National Committee on Uniform Traffic Control Devices

TECHNICAL COMMITTEE: NCUTCD Regulatory/Warning Signs Technical Committee

TOPIC: DO NOT ENTER/WRONG WAY Signing

AFFECTED PORTIONS OF MUTCD: Section 2B.37, 2B.38 and Figure-2B-12

Figure 2B-19. Example of Application of Regulatory Signing and Pavement Markings at an Entrance Ramp Terminal Where the Design Does Not Clearly Indicate the Direction of Flow

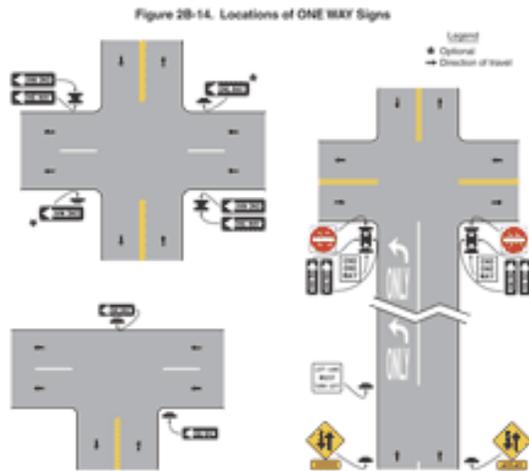
163 04 *On interchange entrance ramps where the ramp merges with the through roadway and the*
164 *design of the interchange does not clearly make evident the direction of traffic on the separate*
165 *roadways or ramps, a ONE WAY sign visible to traffic on the entrance ramp and through roadway*
166 *should be placed on each side of the through roadway near the entrance ramp merging point as*
167 *illustrated in Figure 2B-19.*

Figure 2B-12(rev). Locations of Do Not Enter and Wrong-Way Signing for Divided Highways

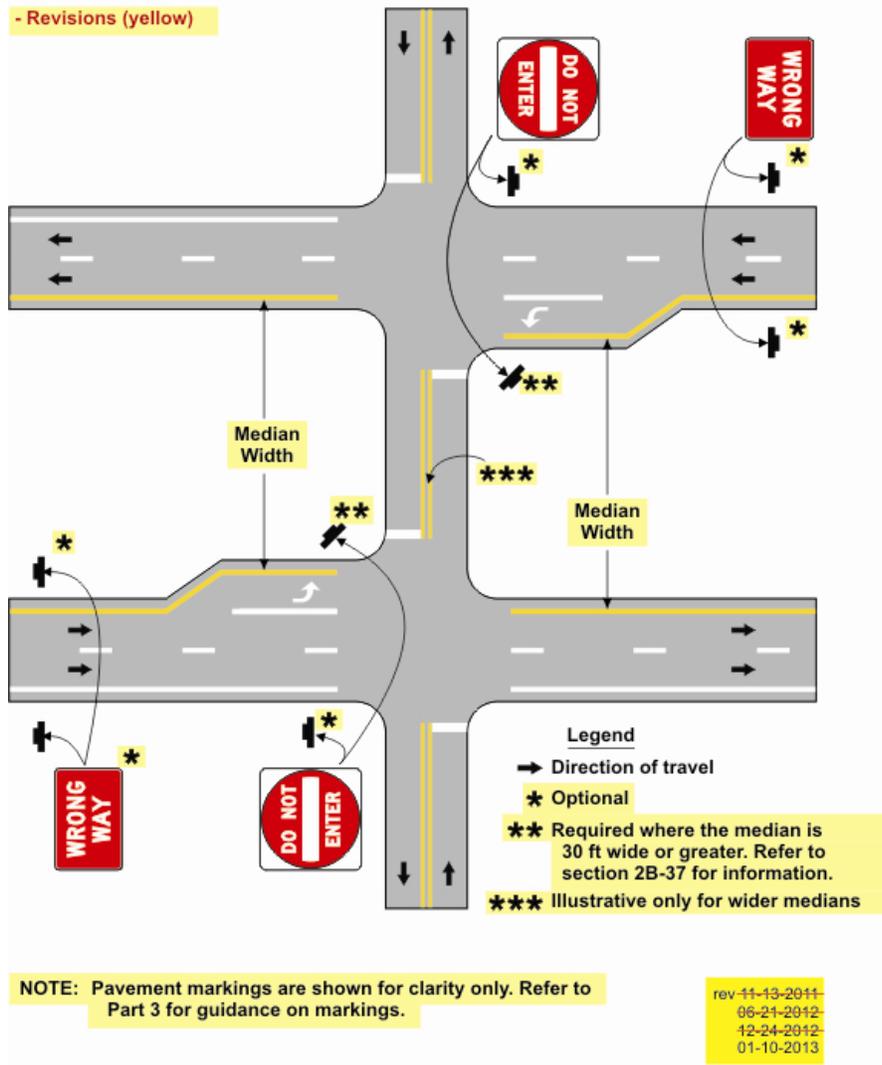
Figure 2B-12 does not provide for situations where the median is less than 30 feet, and does not match the text in terms of wrong way movement signing shown in the text. Also, the figure and text do not adequately address the difference between urban low speed divided highways and high speed rural highways

Figure 2B-12 is inconsistent regarding the WRONG WAY (R5-1a) sign. The text says the signs are optional and Figure 2B-12 does not say they are optional. The text in Section 2B.38 says wrong way signs are optional but figure 2B-18 indicates only one of the WRONG WAY signs is optional.

40
41 Section 2B.38 – WRONG WAY signing – revise figure 2B-12 to show that the WRONG WAY
42 sign is optional for divided highways. Text indicates the sign is optional; therefore, the figure
43 should be changed to match the text. **Change text to match figure.**

194 **Revise Figure 2B-12, Locations of Do Not Enter and Wrong Way Signing for Divided**
 195 **Highways**

196 **The following changes are made to the figure 2B-12:**

- 197 • **DO NOT ENTER signs are optional where the median width is less than 30 feet.**
- 198 • **WRONG WAY signs are optional.**
- 199 • **Section 2B.40 and figures associated with Section 2B.40 describe ONE WAY or**
 200 **KEEP RIGHT signing required for reinforcing wrong way movement.**
- 201 • **Add double yellow center line in median and stop bars for clarity for wider**
 202 **medians. Change WRONG WAY sign to be optional to match text in section**
 203 **2B.38.**
- 204 • **Delete reference to 30 feet or wider on the figure. Figure applies to all median**
 205 **widths with * describing options and ** describing where signs are required.**
 206 **Section 2B.37 providing standards, guidance and options.**
